Additional Information to Independent Planning Commission by City of Parramatta Council

SSD Development Application - Novus Build to Rent, Apartment Tower 39-43 Hassall St Parramatta

The following information has been provided to questions that have been raised by the Independent Planning Commission via letter dated 5th February 2024.

(Council Adopted Flood Study 2005)

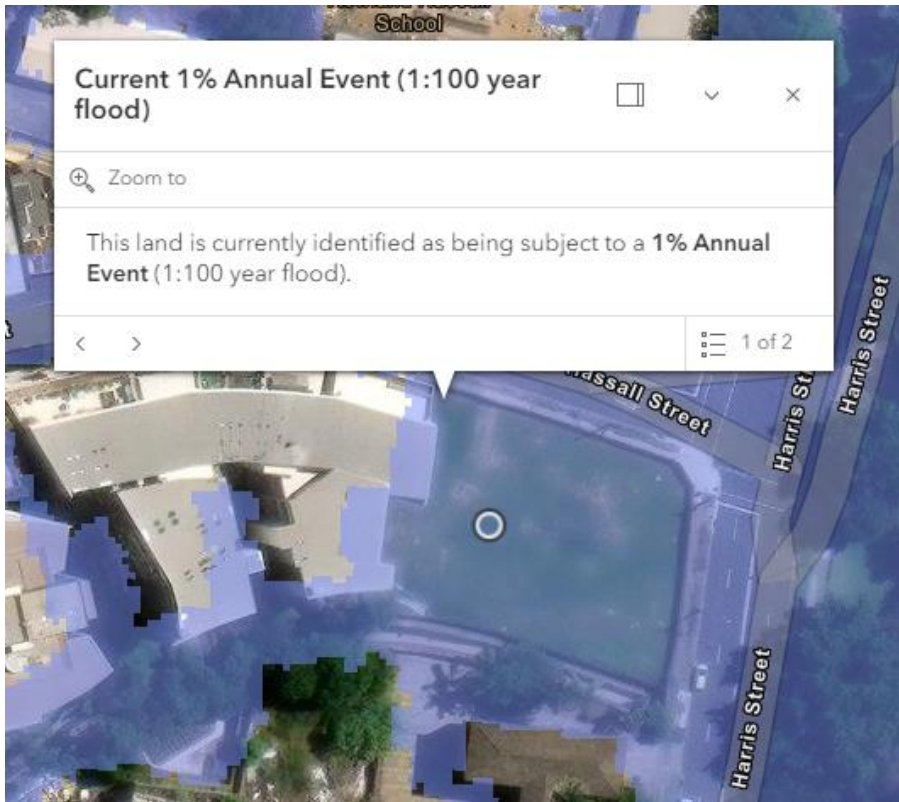
By contrast Council’s 2005 flood maps show all of the site is inundated to high hazard level in a 1% AEP.

Council’s 2023 Draft Flood Study shows all of the site is inundated in a 1% AEP event and all of the site is H3 High hazard in a 1% AEP event.

1% AEP Flood Extent mapping (Council Draft Flood Study 2023)

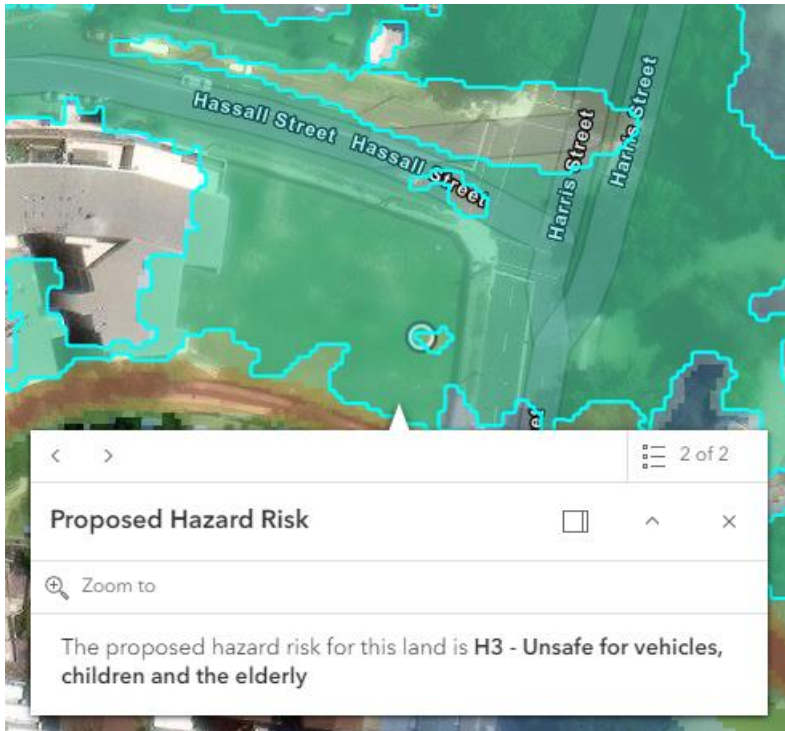
The Lyall model shows only a minor part of the site is inundated in a 1% AEP flood and the corresponding hazard level was H2 low hazard. This was endorsed and not questioned by the GRC Hydro report.

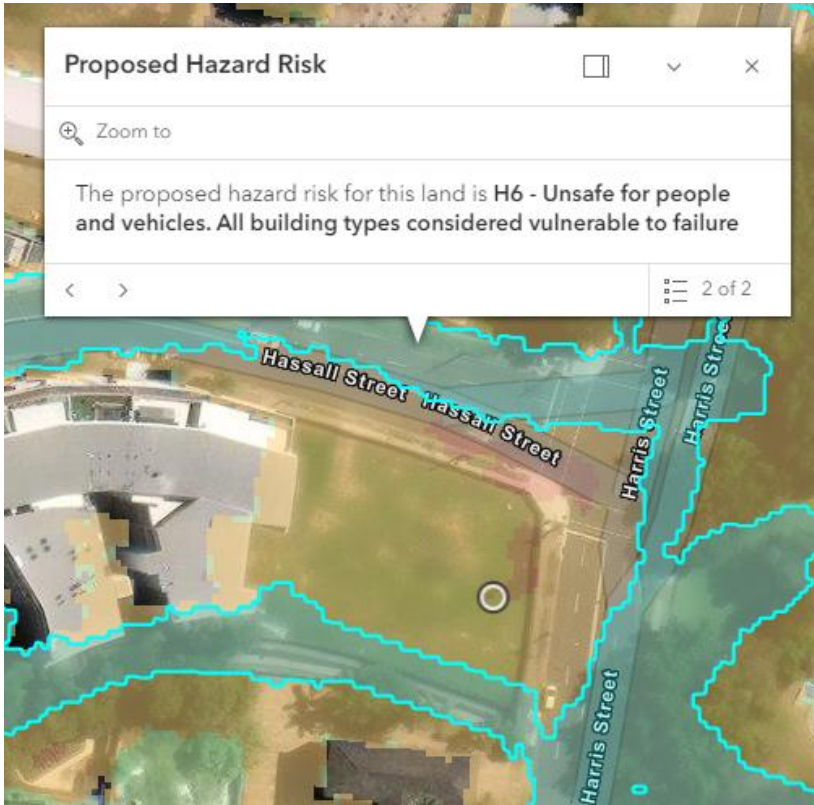
This is not adequate in that information publicly available since November 2023 shows clearly that the entire suite is subject to extreme hazard Conditions **H5 - Unsafe for people and vehicles. All buildings vulnerable to structural damage. Some less robust building types vulnerable to failure**

The surrounding streets and Clay Cliff Creek are predicted to be the most severe Hazard level of H6. This is without modelling the effect of the proposed building itself, which would likely increase hazard conditions around its edge to **H6 - Unsafe for people and vehicles. All building types considered vulnerable to failure.**

PMF Hazard map from Councils Draft Flood Study 2023(H5)

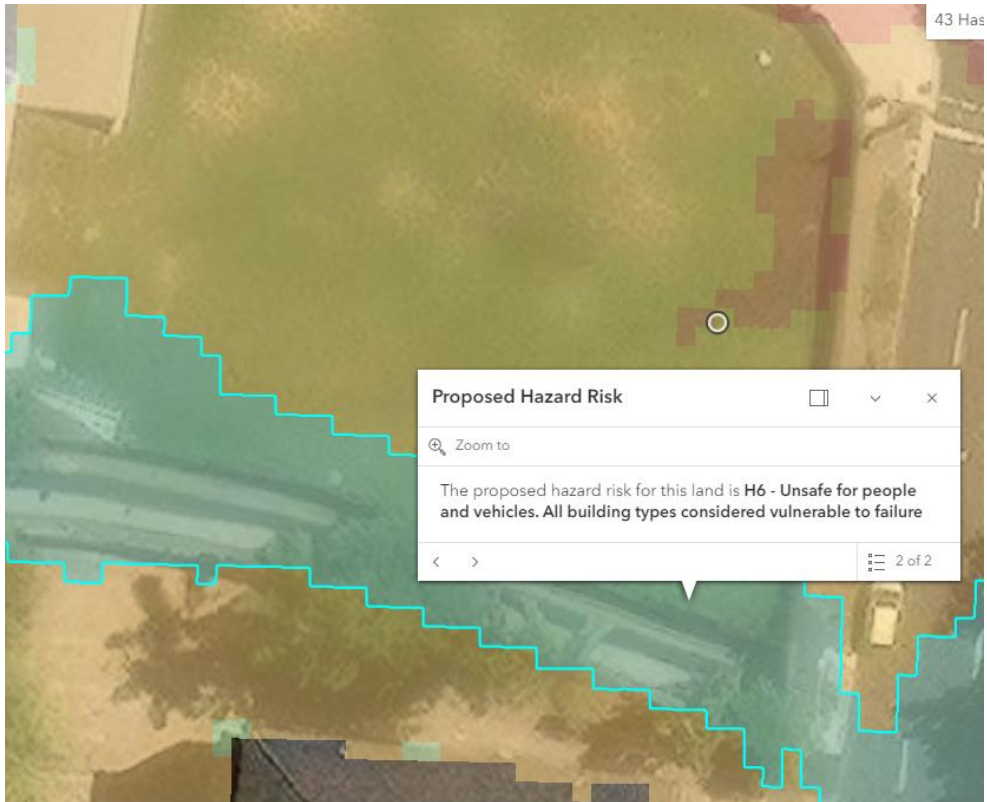
Underestimate of PMF flood hazard by Consultants – Council draft study predicts H5, across all of site and H6 on north, east and western sides. This is modelled with no building on site, so no obstruction of flow. Impacts of obstruction of floodway by building are not yet known but likely to increase hazard to potentially H6 resulting in building destruction and significant off-site impacts.
